63-65 Upper Chorlton Road

Addendum to application to discharge Condition 23 (Windows)

Above - plan showing locations of affected windows

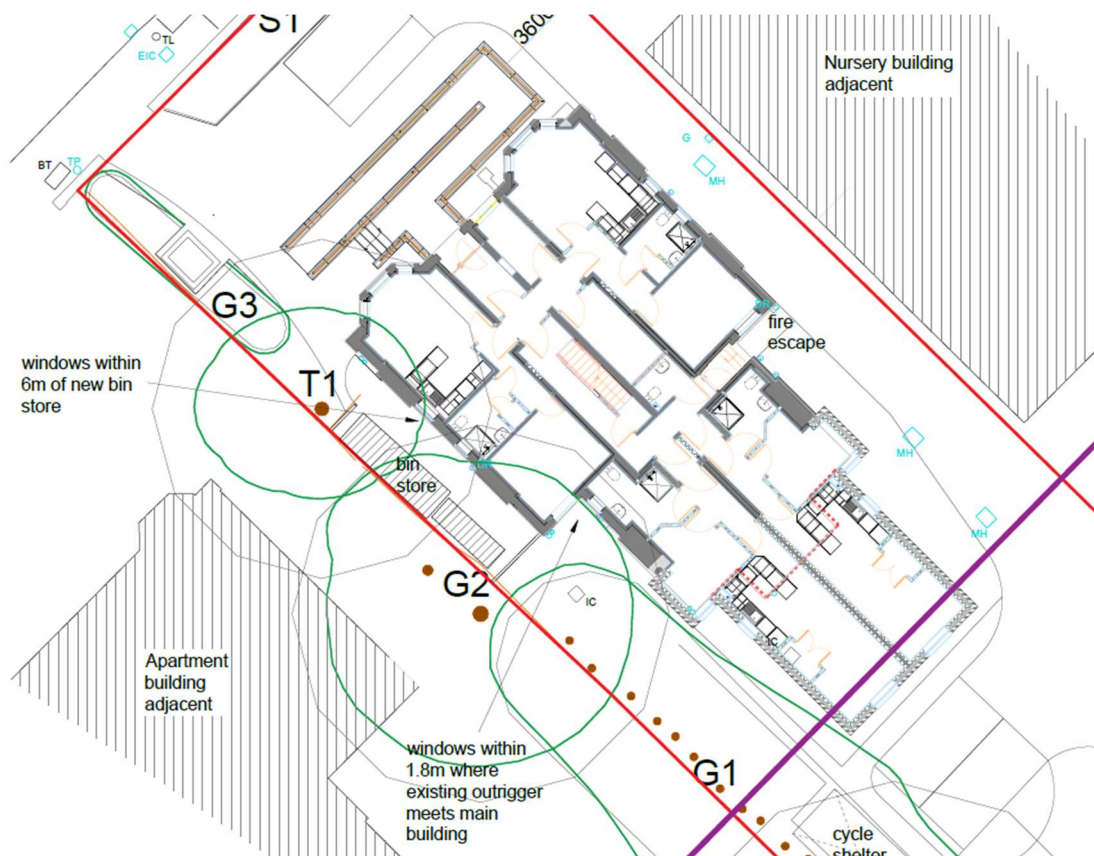
Currently a discharge application has been submitted in relation to the condition based on the use of triple glazed UPVC windows with a 52mm sightline (i.e. the width of the outer face of the frame). However the Fire Risk Assessment for the proposed design has identified areas where fire rated windows are required to meet Building Regulations or to provide adequate fire safety. These fall in two locations, as follows:

1. In situations where windows are within 1.8m of one another on flanking elevations. This occurs where the original rear outrigger meets the main house – i.e. the main bedroom windows in the rear elevation are within 1.8m of the bathroom windows in the side elevation
2. Where kitchen and bathroom windows are within 6m of the new external bin storage area. This occurs on the south facing gable elevation of the main house

Above - elevation showing affected windows

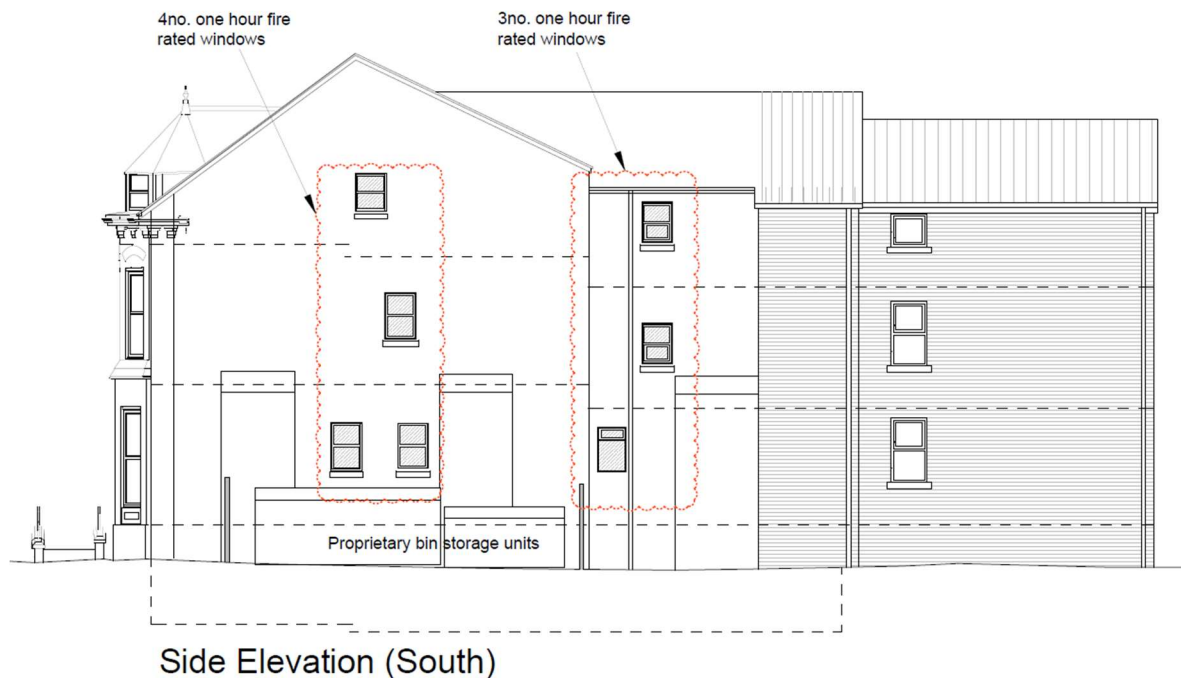
As part of a separate Section 73 application it is intended to modify the design to remove the need for fire rated windows on the elevation facing the nursery. This is not possible on the south facing elevation, therefore the intention is to replace some of the upvc windows with an aluminium equivalent. These are highlighted below

Due to the change in performance, the smallest section available for these windows has a 61mm sightline. This is an aluminium triple glazed product from the Aluprof MB-78 range, frame reference K518142. External colour of these frames will be grey to match the remaining upvc windows. A brochure is included as part of this submission.
